ADDENDUM 2

ADDENDUM DATE: July 5th, 2019

PROJECT: Asheboro City Schools – Kitchen Renovations

ARCHITECT: Smith Sinnett Architecture, P.A.

Attachment ADD - 1-01

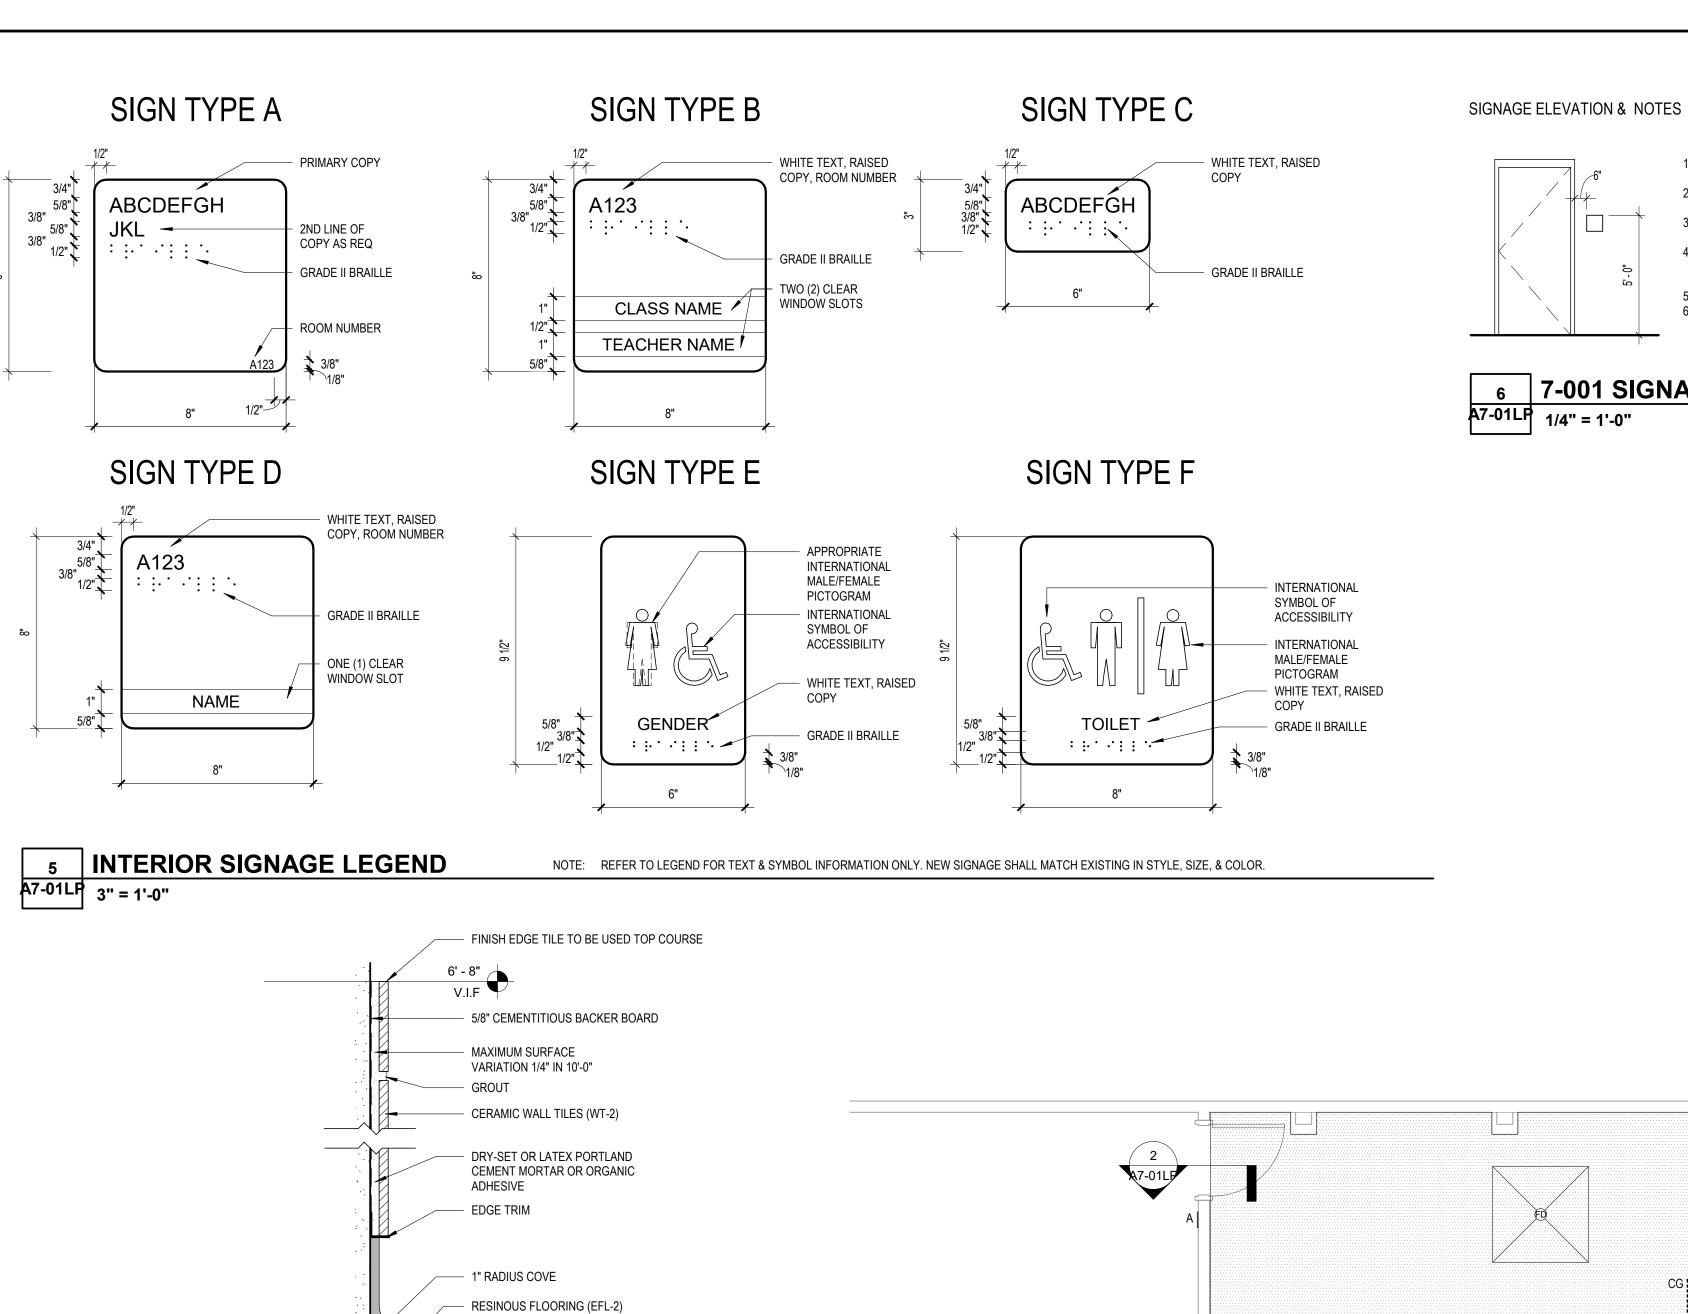
Item 1 <u>ADD:</u> Proposed Lay Down Area

See Attachment ADD - 1-01

FIRST FLOOR FINISH PLAN

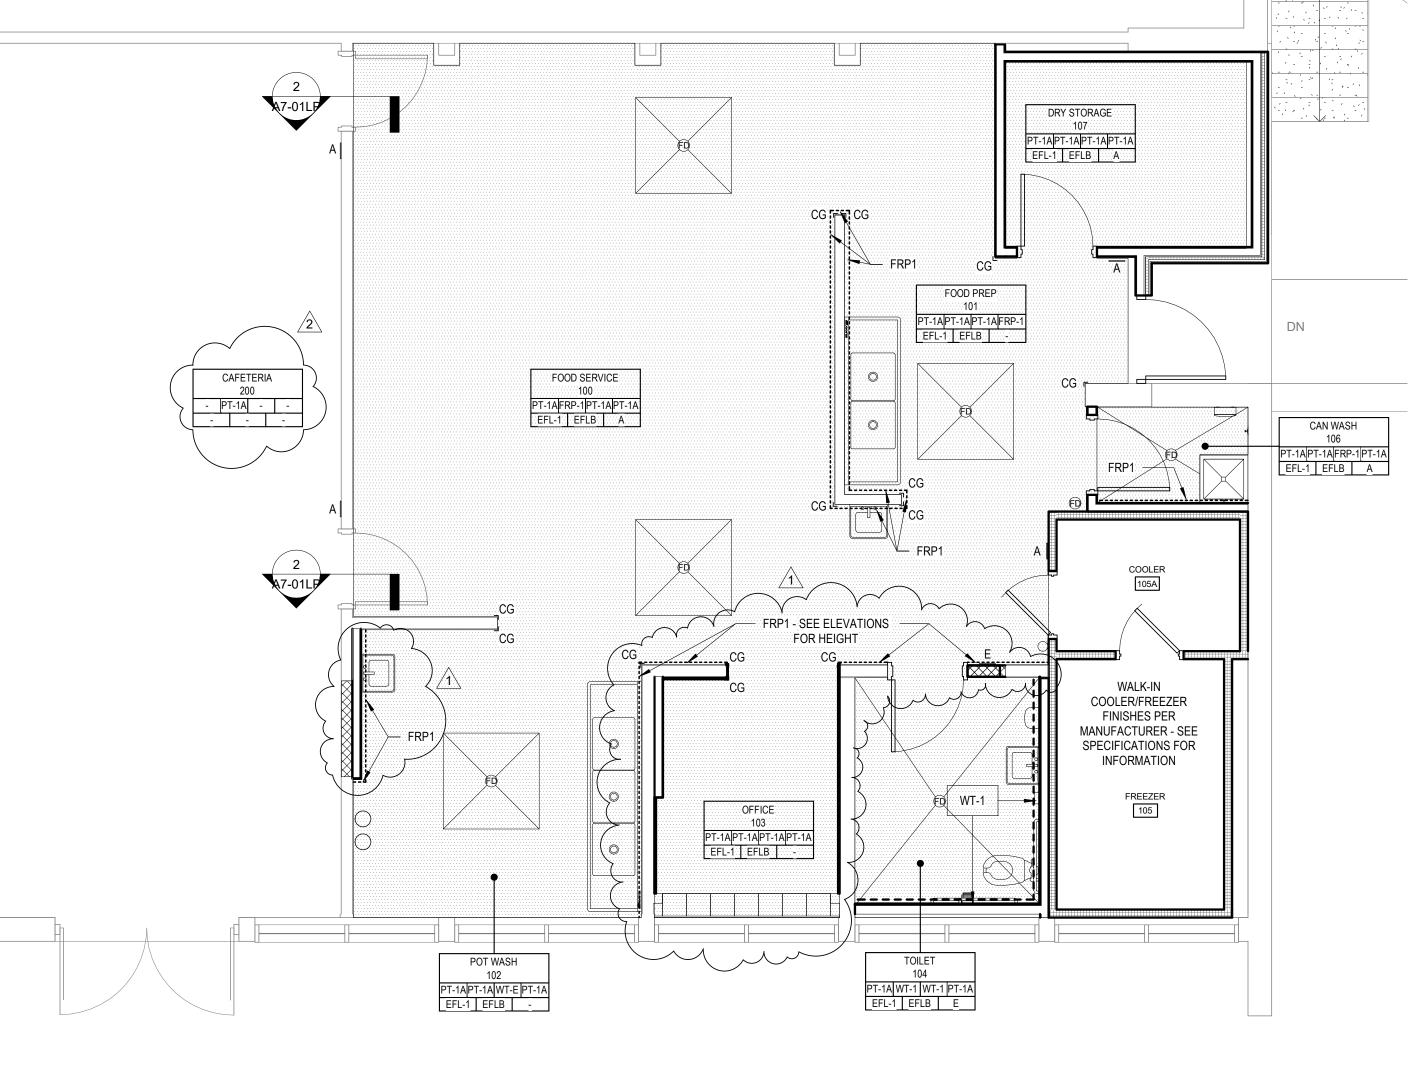
Item 2 REPLACE: Sheets A7-01LP. Revised sheet provides finish information for Cafeteria #200. The existing

CMU wall separating Cafeteria #200 from Kitchen will be painted (PT-1A)

S0-03MC

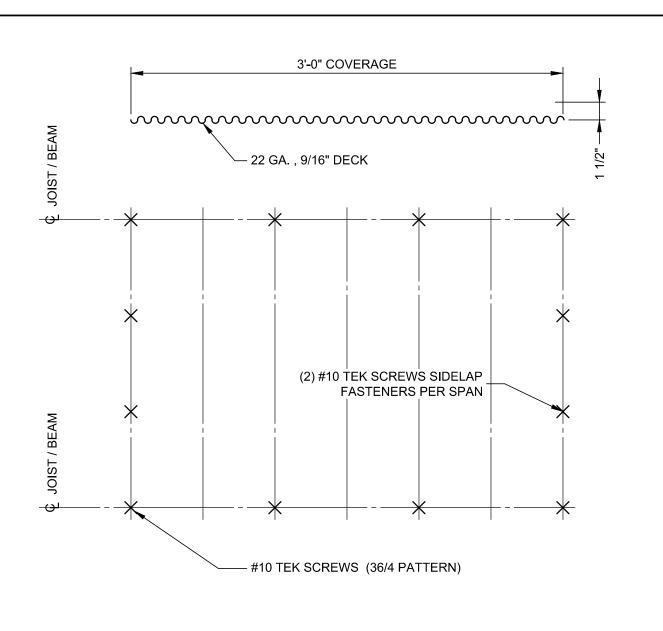
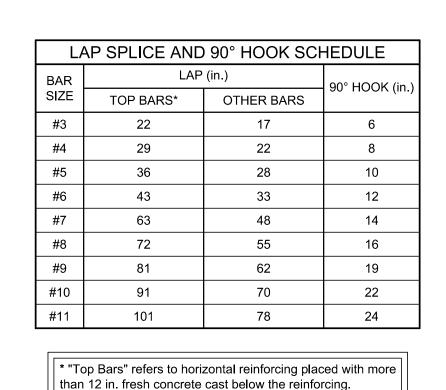
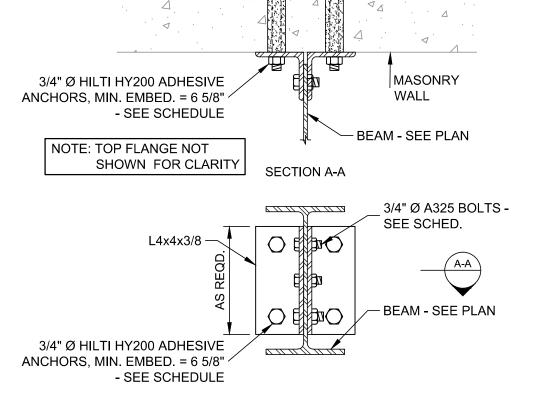
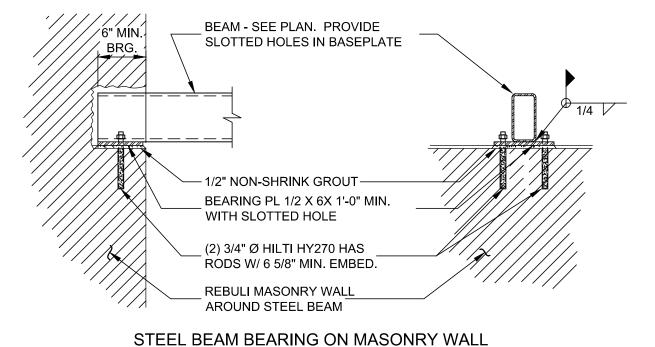
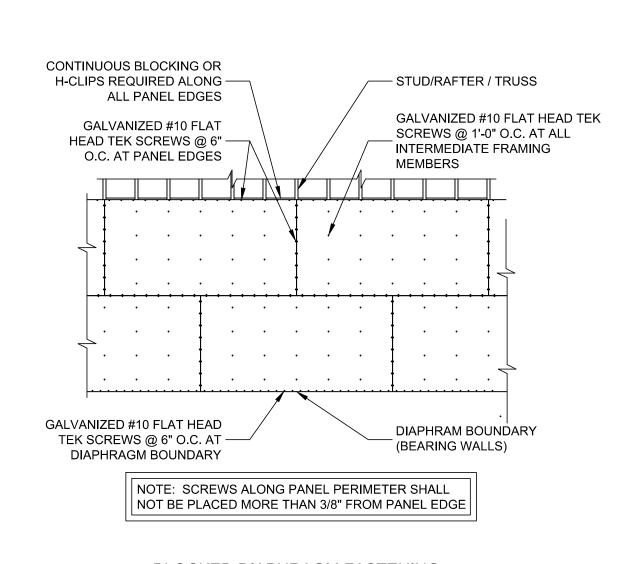
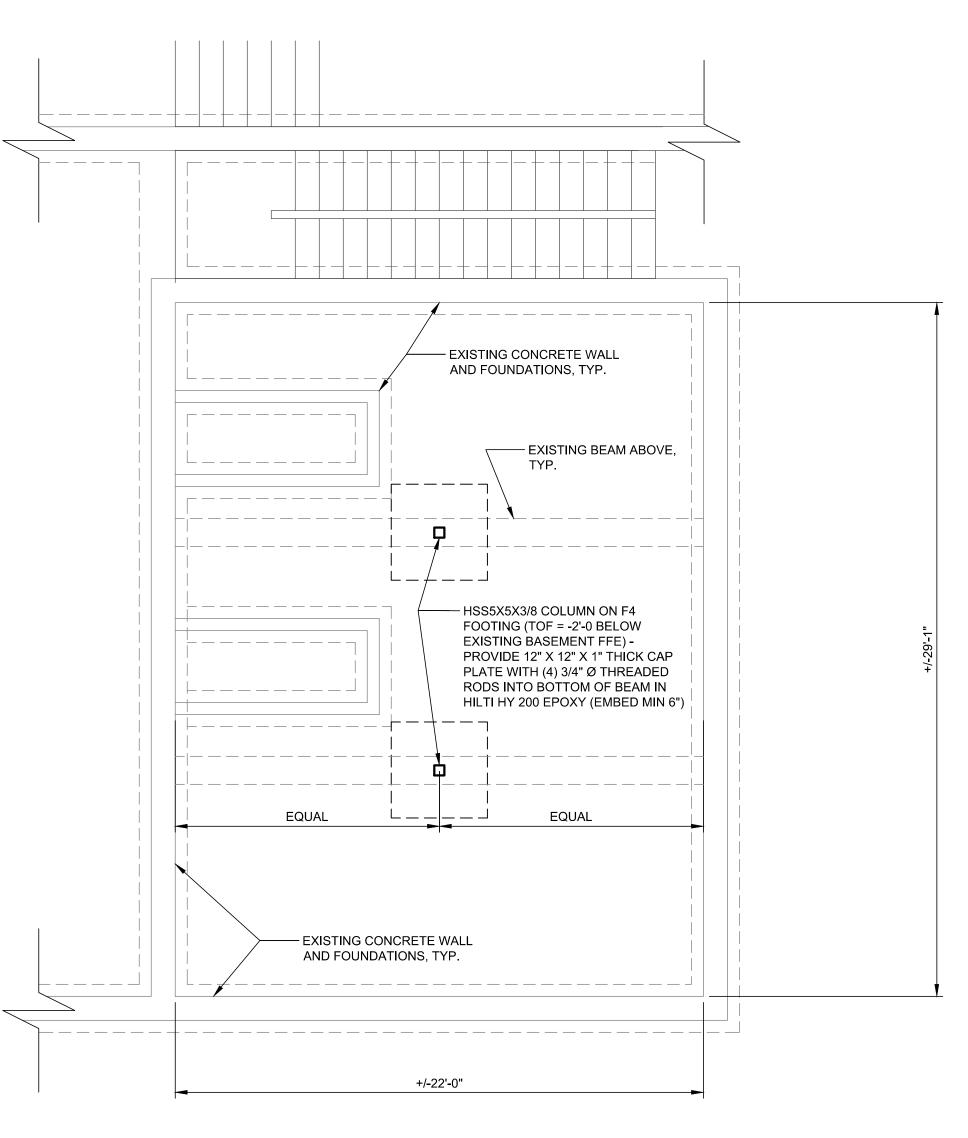
Item 3 REPLACE: Sheets S0-03MC, S1-01MC, and S1-02MC. Revised sheet provides an updated masonry

lintel schedule to account for 6" CMU walls and provides additional information for keying locations where

typical detail "concrete slab infill" is applicable.

S1-02MC

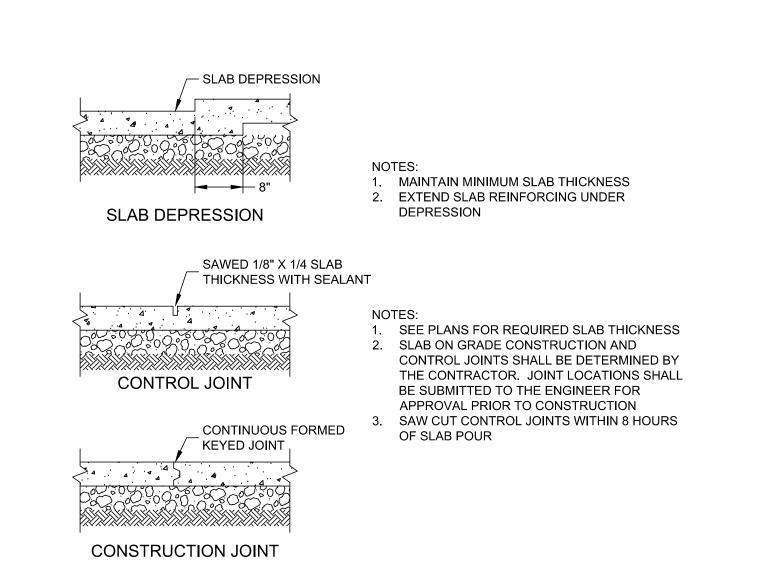
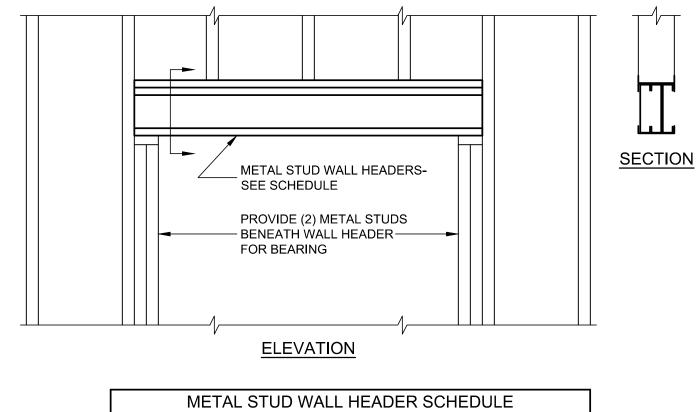
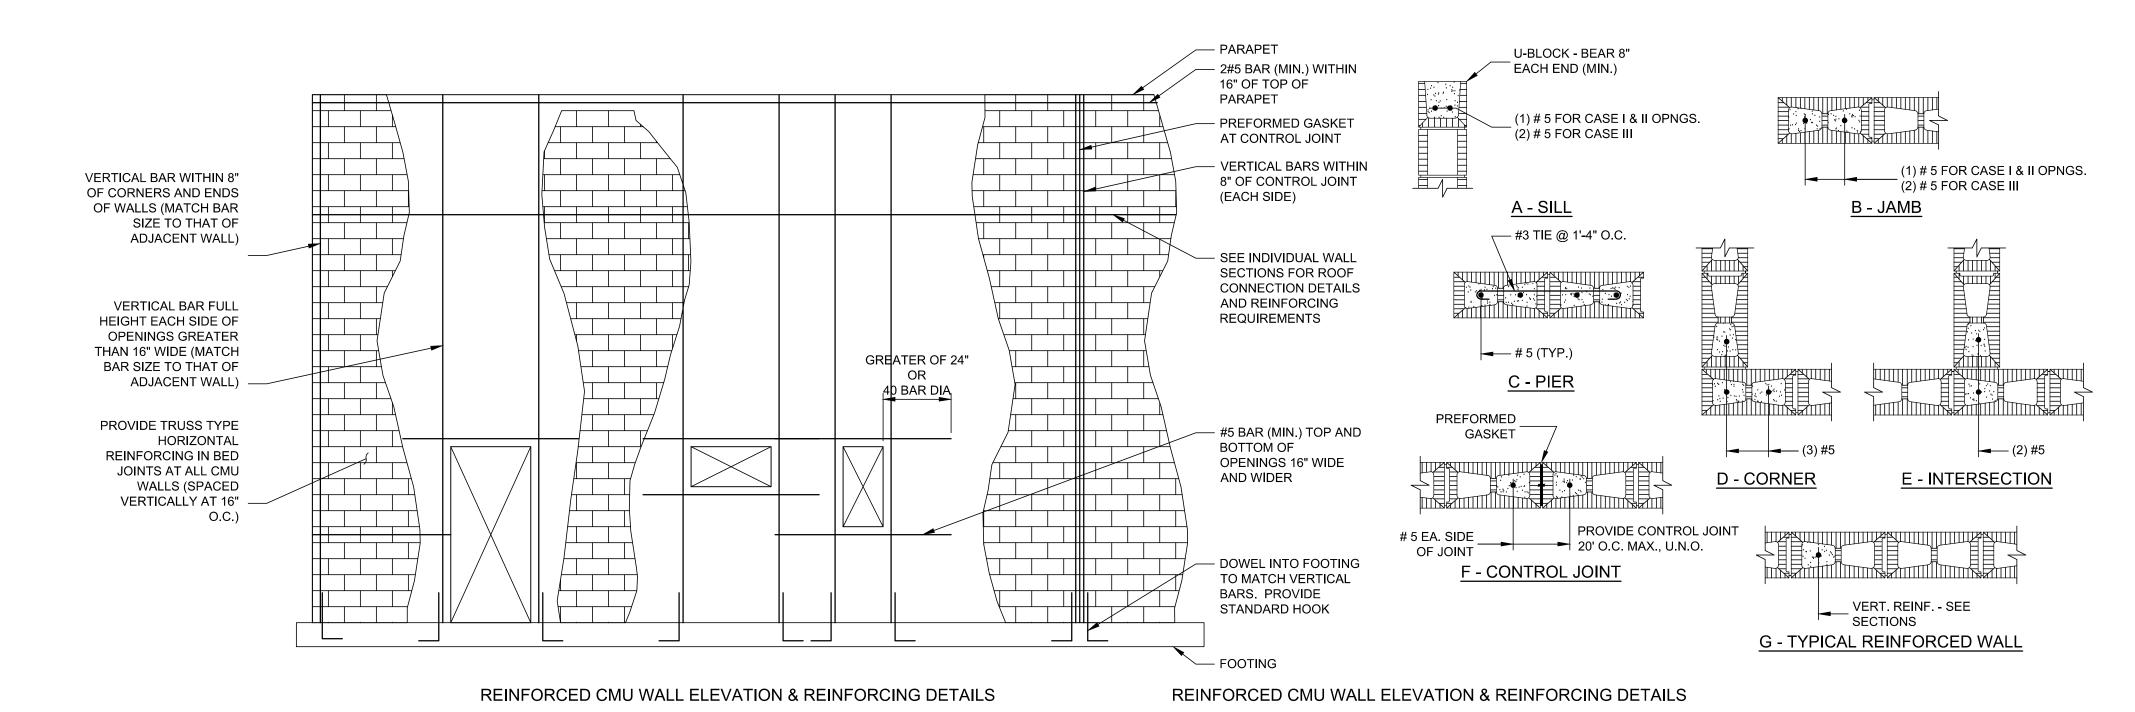
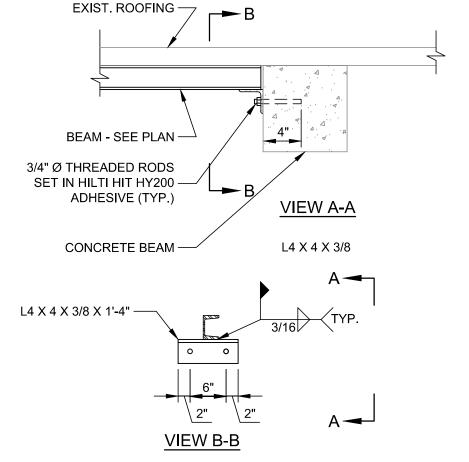
Item 4 REPLACE: Sheets S0-02LP. Revised sheet provides an updated masonry lintel schedule to account for 6" CMU walls.
